Product Discontinuation

PDN-IFC-7989-2022

Business Unit	Product Line Code	Type of Change	Action	Date of Issue
IFC - Industrial Field Connectivity	BF7	Product Discontinuation	Notify Distributors and Field	7/6/2022

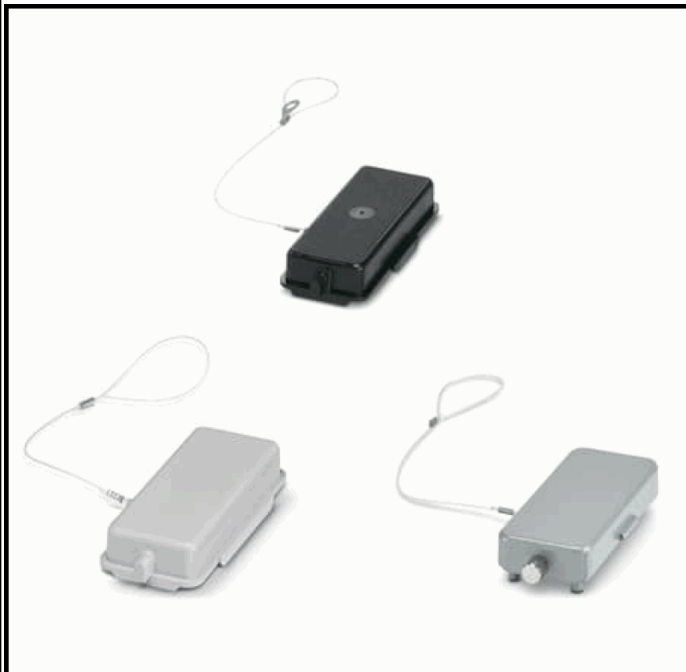
Due to ongoing product improvements, Phoenix Contact has developed and added many new and optimized HEAVYCON protective covers to the product portfolio. The previous protective covers in HEAVYCON series B06, B10, B16, B24, D15, and D25 are therefore being discontinued. The improved and optimized versions will replace each discontinued item.

The new HEAVYCON protective covers differ from the previous products in terms of their shape and material. The technical properties of the new protective covers are either the same or better than the previous versions. The new material is Polycarbonate, is UV resistant (UL 746 C f1 listed), has a UL 94 V0 flammability rating, and provides an IP66 seal.
